Proposed changes to the 1000BASE-X PCS Receive state diagram

Jacobo Riesco and Adam Healey
LSI Corporation
November 17, 2009

This proposal is intended to address IEEE P802.3az/Draft 2.1 comments #14, #139, #147, #148, and #149. The proposed state diagram merges the existing LPI Receive state diagram (Figure 36-9a) with the PCS Receive state diagram (Figure 36-7). Figure 36-9a is removed. Modifications to the original PCS Receive state diagram (Figure 36-7a) are minimized to more clearly delineate supplemental requirements for the optional Energy Efficient Ethernet capability.

Figure 36–7a – PCS Receive state diagram, part a

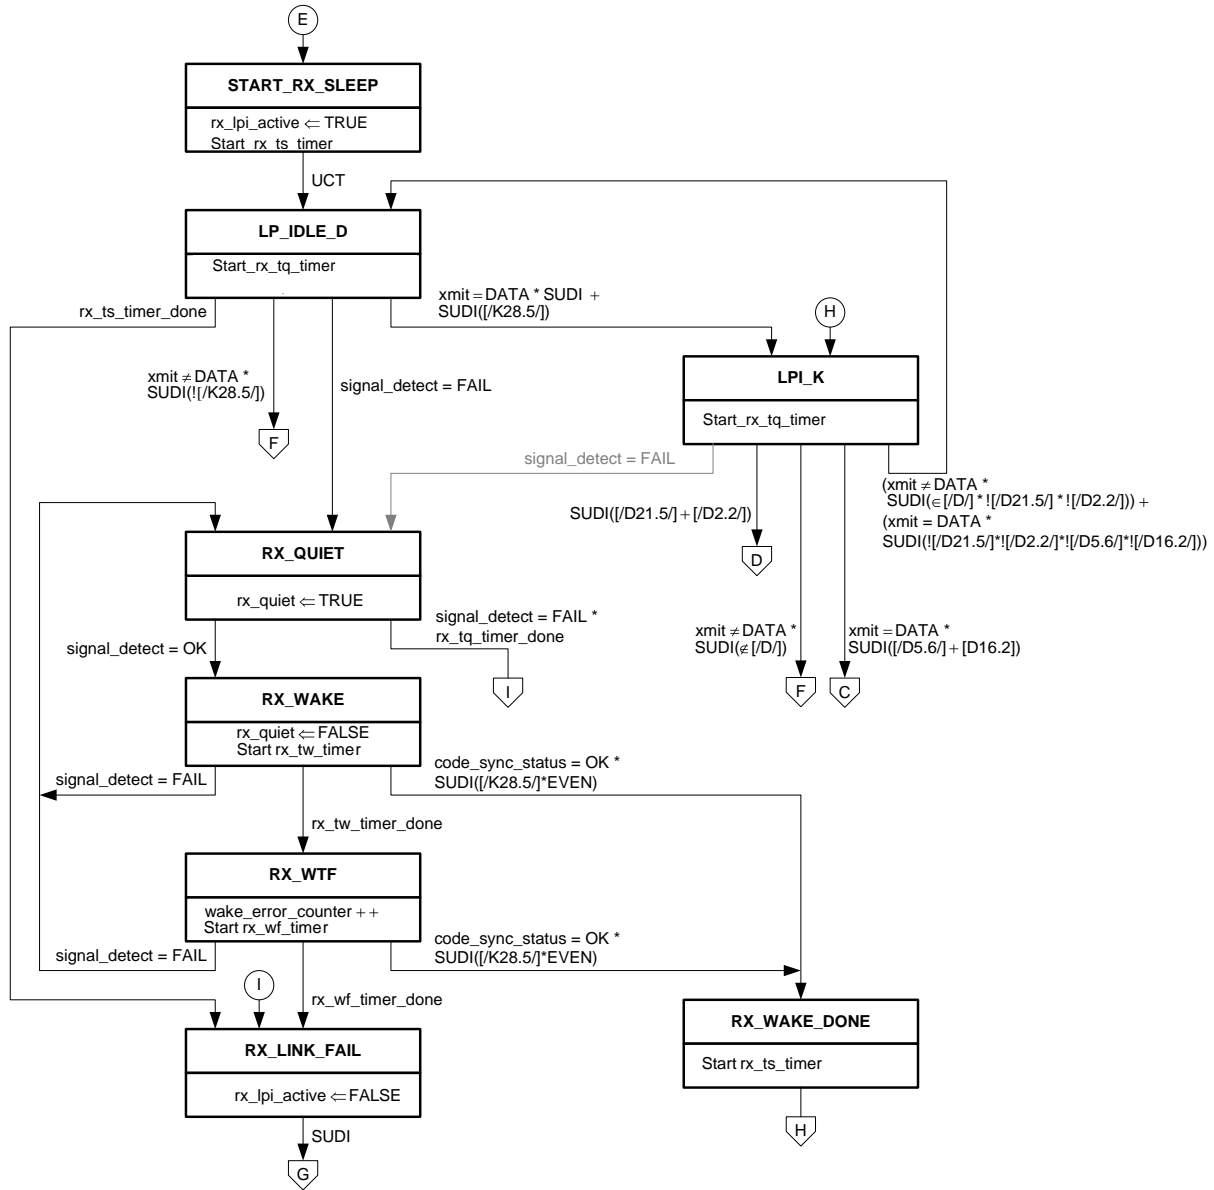
The `sync_status` variable is re-defined so that it is set to `TRUE` when either `code_sync_status = OK` or `rx_lpi_active` is `TRUE` and is set to `FALSE` otherwise.

Remove aliases `detect_idle` and `detect_lpidle`.

A new alias `idle_d` is defined to be `SUDI(!/D21.5/#!/D2.2/)`. When the optional EEE capability is supported, the alternate definition `SUDI(!/D21.5/#!/D2.2/#!/D6.5/#!/D26.4/)` is used.

A new timer, `rx_ts_timer`, has been introduced to time-out the “sleep” period. Note that `code_sync_status` is (and has to be) ignored in those states, as synchronization could be lost when the line goes quiet. Its value, T_{SR} should be slightly larger than the transmit sleep timer value, T_{SL} (20 μ s). This is similar to the approach taken in the 100BASE-TX Receive state diagram. The proposed range for T_{SR} is 22 to 24 μ s.

Replace Figure 36–7a with the following:

Figure 36–7c – PCS Receive state diagram, part c (only required for the optional EEE capability)

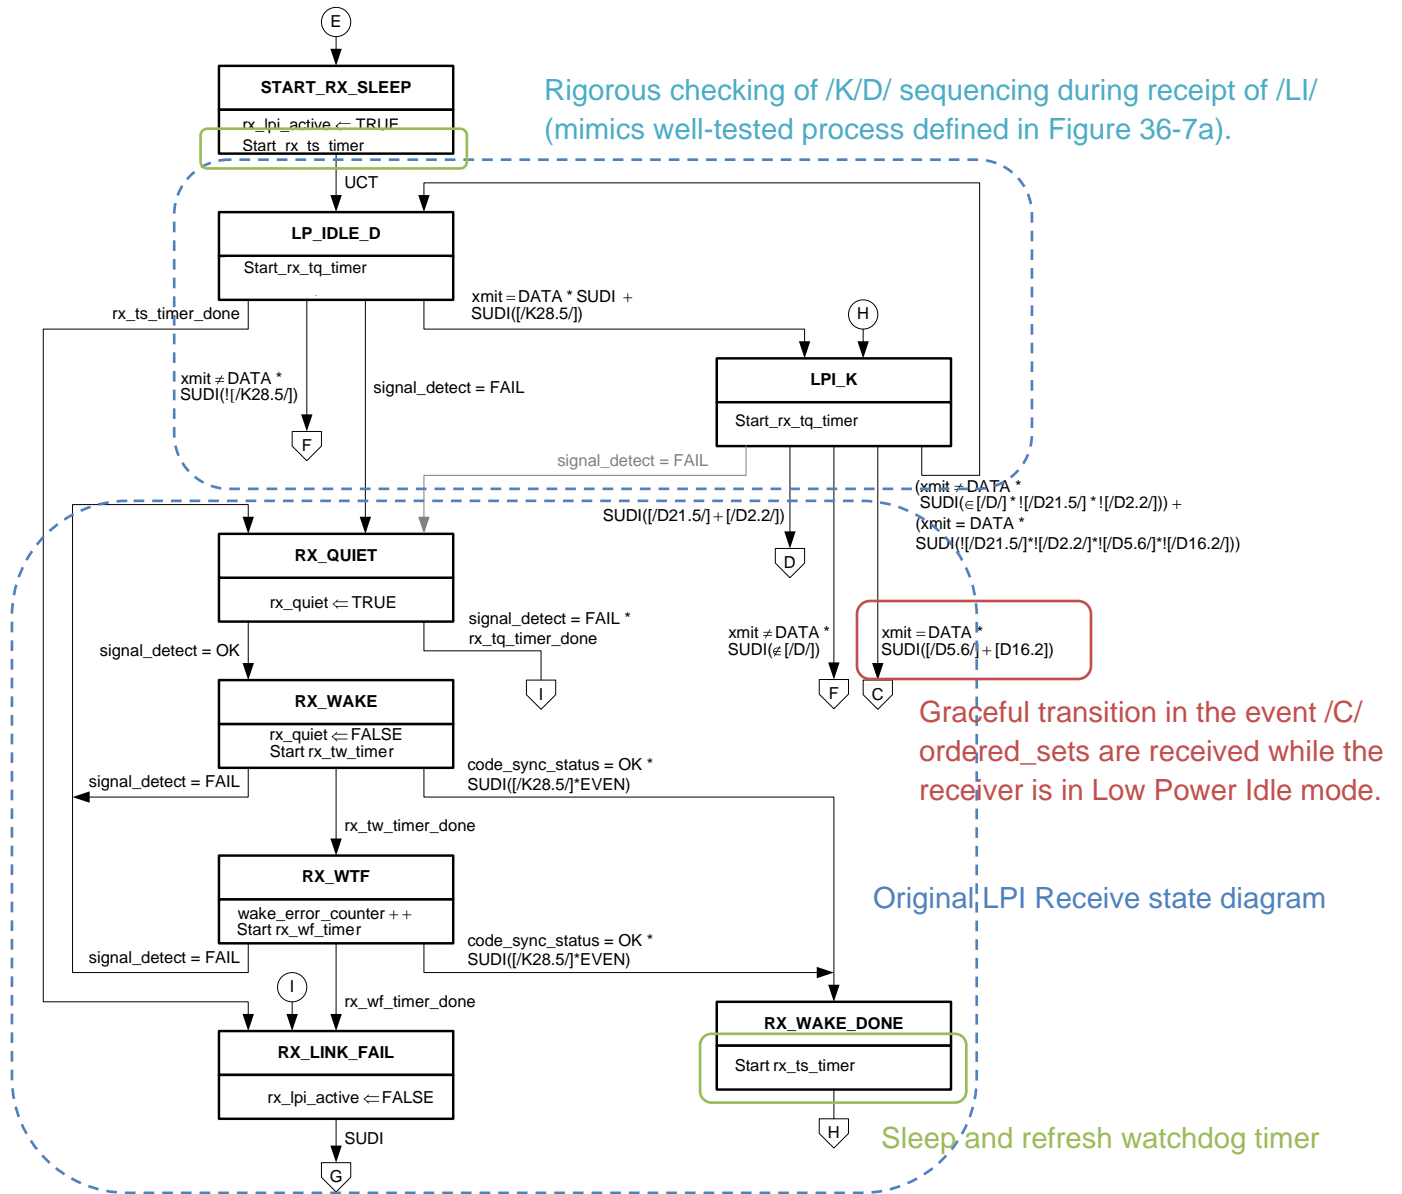
There was another issue with the state diagram that was observed after the comment deadline. The condition `detect_idle * ODD` could become true at the receiver when the transmitter ceases transmission (for example, an entire code-group is not received). As currently specified, `detect_idle` will be set to true on any received code-group that is not /D21.5/, /D2.2/, /D26.4/, or /D6.5/. This condition could be satisfied by a truncated code-group. This would cause a transition from `RX_SLEEP` to `RX_ACTIVE` instead of `RX_QUIET` which would eventually result in link failure.

Insert Figure 36–7c:
